**DECISION NOTICE FOR OPERATIONAL WORKS  
(SECOND CROSSOVER & APRON) – 65 REEF STREET, PORT DOUGLAS**

**DECISION NOTICE FOR OPERATIONAL WORKS  
65 REEF STREET, PORT DOUGLAS**

Operational Works (2<sup>nd</sup> Cross Over & Apron) & Existing Access onto Limpet Avenue

Drawing Description	No	Rev
Site Plan - As Submitted with the Application	N/A	N/A

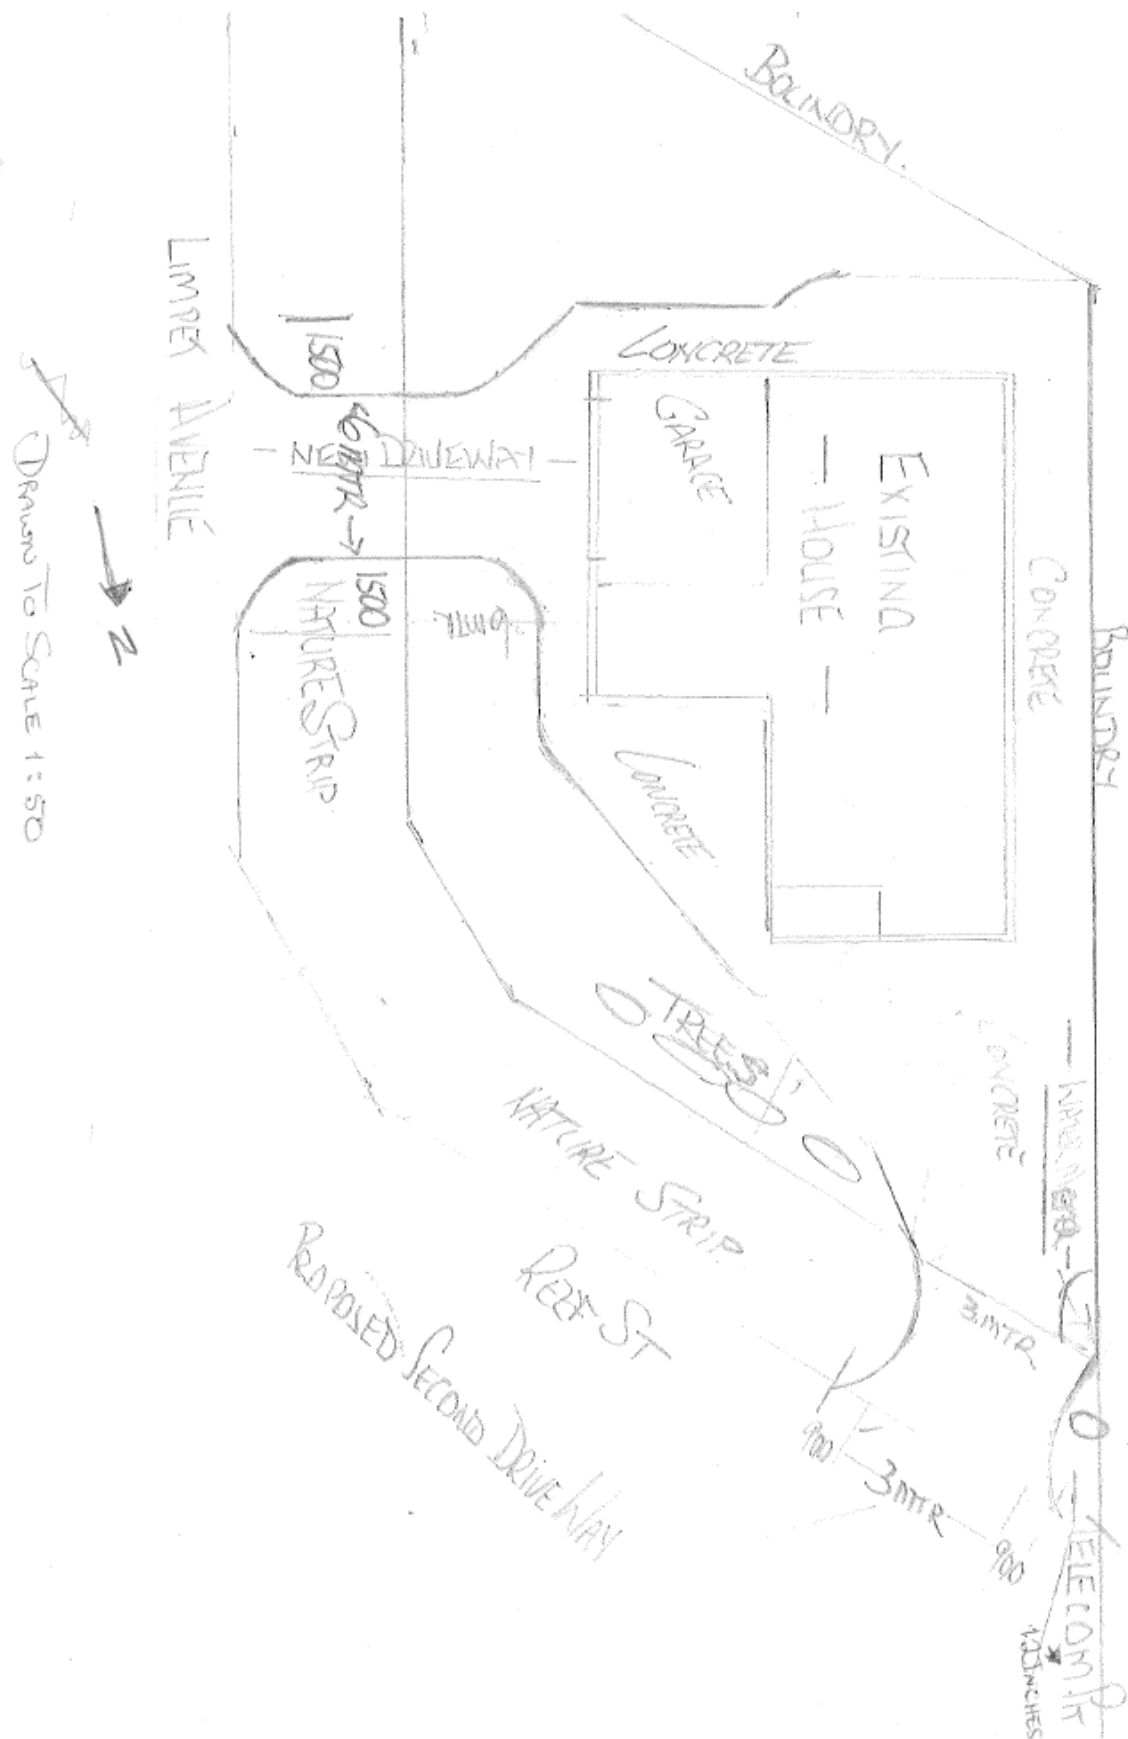
1. The location of the driveway fronting Reef Street must be amended to comply with the following requirements:-
  - a. Locate the driveway further down Reef Street to provide a 500mm clearance from the edge of the driveway to the water meter and to increase the clearance of the driveway from the existing Telstra pit located within the Reef Street road reserve.
  - b. The crossover and apron must be constructed at right angle to the kerb and channel and must be constructed in accordance with the Standard Drawing S1015 Issue C as detailed in the FNQROC Development Manual. A copy of the Standard Drawing is attached.

Prior to the concrete being poured for the cross over and apron, the applicant must notify Council and have the works inspected and approved.
